Planning Commission Staff Report

Project type: Amended Site Development Section Plan

Location: 17365 Chesterfield Airport Road.

Description: **Chesterfield Commons Six, Lot 3 (ASDSP):** A Third Amended Site Development Section Plan, Amended Landscape Plan, Lighting Plan and Amended Architectural Elevations for a 1.28 acre tract of land zoned “C-8” Planned Commercial District located on the north side of Chesterfield Airport Road and west of Boone’s Crossing.

Figure 4: Amended Site Plan

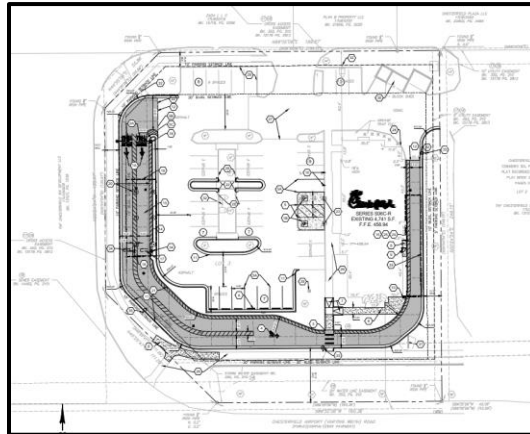
The existing site experiences undesirable congestion issues. Currently, the drive-thru customers for Chick-fil-A extends beyond the property line queueing onto Arnage Rd. (private street). In order to accommodate all the drive-thru customers inside the site and prevent conflicts between the drive-thru customers and customers seeking to park in the lot, the restaurant is expanding their existing two-lane drive-thru lane and eliminating 14 of the existing parking spaces from the site plan. The existing menu board and canopy on the south are proposed to be relocated to the east of the property.

In particular, Staff would note concerns with satisfying requirement 3. to alleviate traffic congestion.

Figure 5: East side Elevation

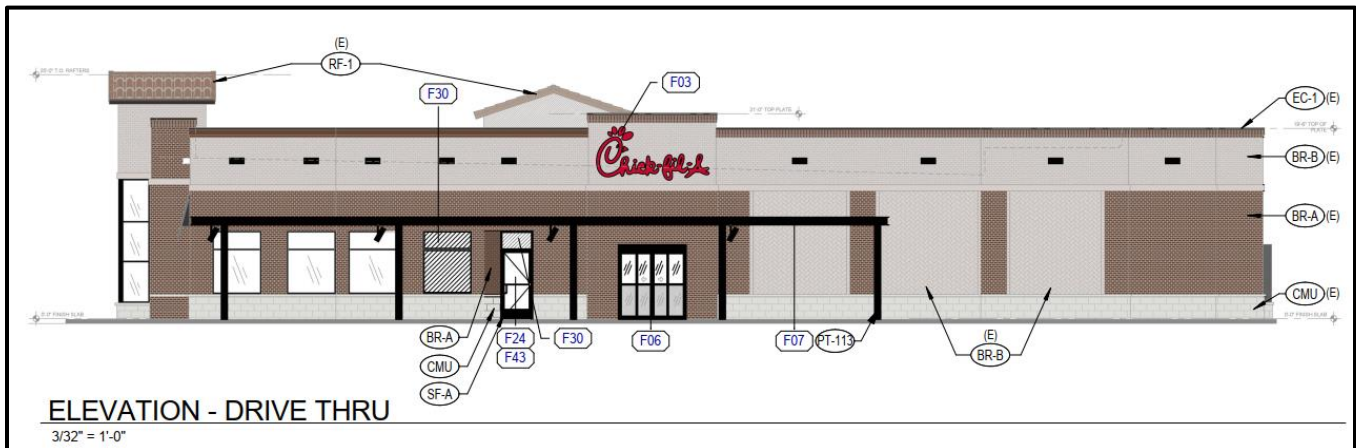
Applicant is amending the East Elevation to include a new canopy to service the drive thru. The existing canopy and menu board along Chesterfield Airport Road are proposed to be relocated to west side of the subject site.

Figure 7: Proposed Landscaping

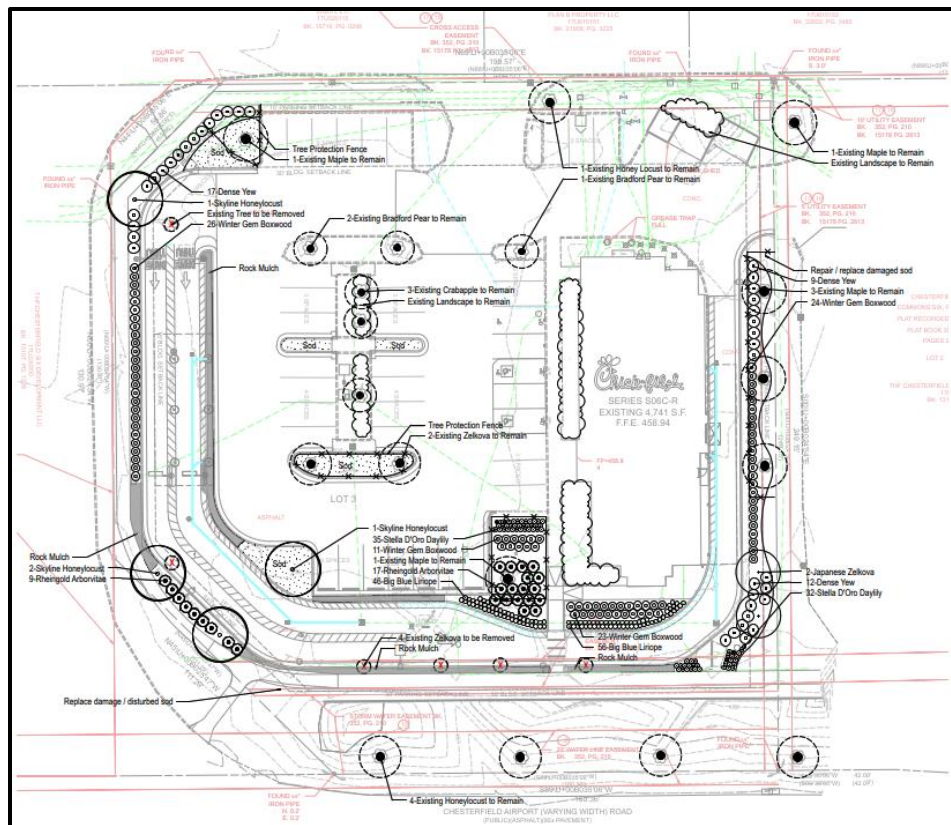
The Amended Landscape plan replace/relocate Six (6) existing trees, and include groundcovers and shrubs.
